Groton Wind, LLC

Docket No. 2010-01

Record Request: Redrawn line of sight cross-section sheets (from visual impact study) with correct turbine heights as well as new line of sight calculations.

**Reference:** Revised Groton Cross Sections

Sheet 2 of 5 - Section A-A'

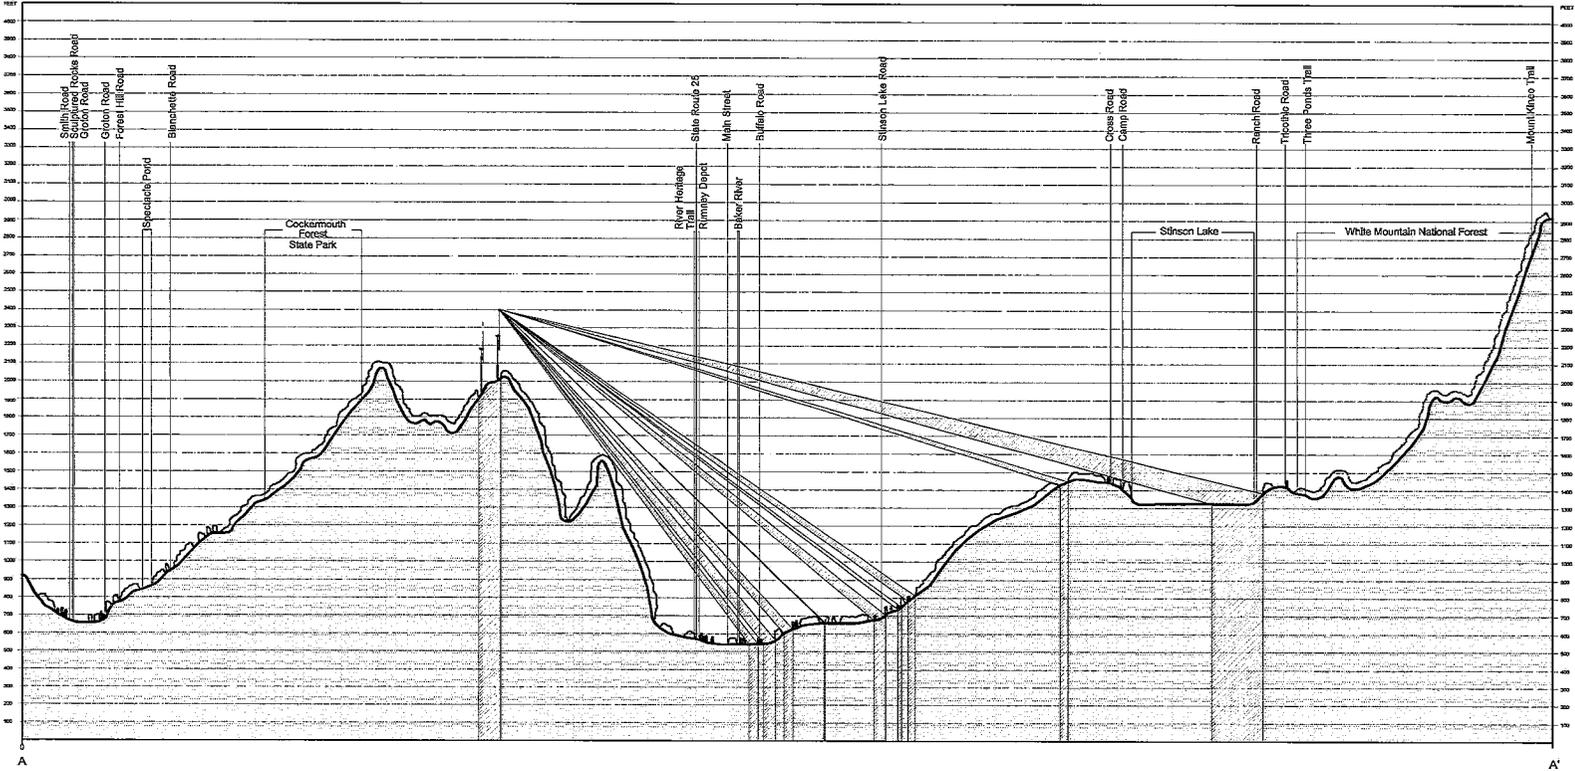
Attached is revised Figure 9 (Sheets 2-5) of the Groton Visual Impact Assessment (VIA). The figures have been corrected to show a 399-foot turbine height and associated areas of potential turbine visibility. Additionally, we recalculated the percentage of visibility along each section line. Revised visibility calculations are presented below:

Total Length of Section	Approximate Length with Turbine Visibility	Percent with Turbine Visibility
Section A-A'	15.9 mi.	7600' +/-	9.0 %
Section B-B'	13.4 mi.	2900' +/-	4.1 %
Section C-C'	18.2 mi.	3400' +/-	3.5 %
Section D-D'	15.2 mi.	1300' +/-	1.6 %
